City of **HOBART**

## APPLICATION UNDER HOBART INTERIM PLANNING SCHEME 2015

Type of Report: Committee  
Committee: 4 July 2022  
Expiry Date: 11 July 2022  
Application No: PLN-21-881  
Address: 110 REGENT STREET , SANDY BAY  
ADJACENT ROAD RESERVE  
Applicant: Mark Neo  
C/- 60 Barrack Street  
60 Barrack Street  
Proposal: Partial Demolition, Carport, Front Fencing and Work in Road Reserve  
Representations: None  
Performance criteria: Inner Residential Zone Development Standards, Parking and Access Code and Historic Heritage Code

Figure 3: Proposed Site Plan

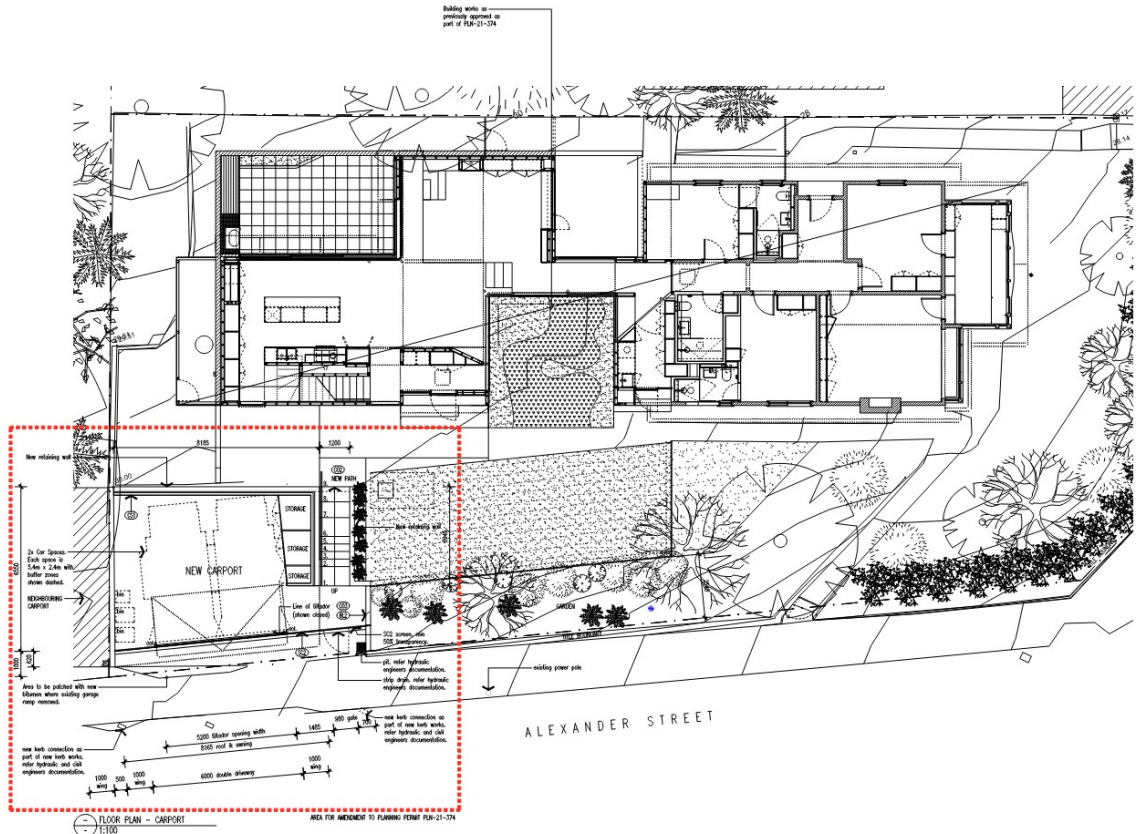
6.7.4 The Council's Development Engineer is satisfied that the sight lines may be accepted under Performance Criteria P1:E6.7.2 of the Planning Scheme. Given the location of the access and driveway, and the low volume of traffic on the road from which the property gains access.

The proposed development of a new garage with a flat roof in the same approximate location as the existing is considered acceptable and will not result in detriment to the historic cultural heritage significance of the precinct. The proposal complies with Performance Criteria 1 of E13.8.2.

6.9.5 The front fencing proposed is only a small portion (less than 5m) of this frontage, on either side of the car port. The remainder of this frontage remains either open, or fenced with a lower, already approved (PLN-21-734), front fence set back in the order of 2.5m from the frontage. It is noted that the proposed fencing has a transparency that meets the exemption requirement (30%). It is also noted that the assessing Cultural Heritage Officer has indicated support for the front fencing. It is considered that the proposed fencing will allow for passive surveillance of the road, while still allowing for the privacy of residents using the car parking area. It is also considered that the fencing will be compatible with the height and transparency of front fences in the street, of which there is an eclectic variety.

Figure 4: Proposed Elevation

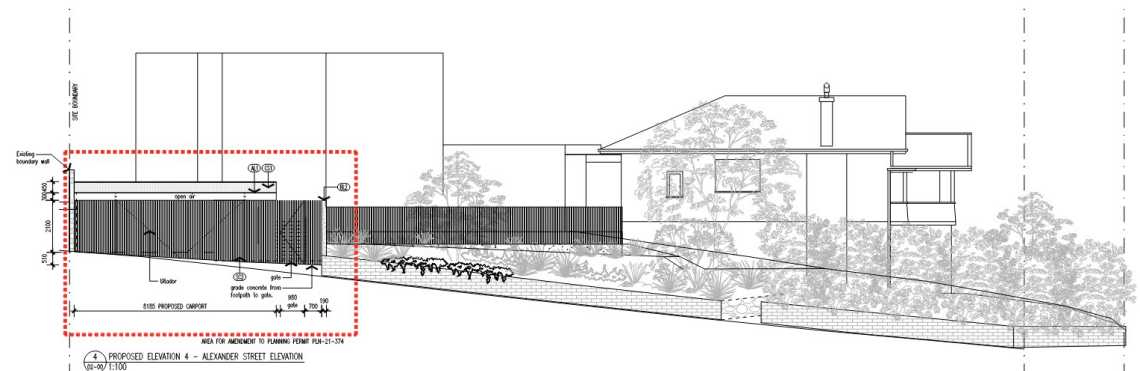
The proposed fencing is considered acceptable in terms of height and scale giving the surrounding context, and the existing fence of a similar height. The proposed fencing development is deemed to meet Performance 4 of E13.8.2.

6.9.2 The proposal includes a front fence that is between 2/1m and 3.1m height, on the site's Alexander Street frontage, on either side of the tiltadoor for the carport.
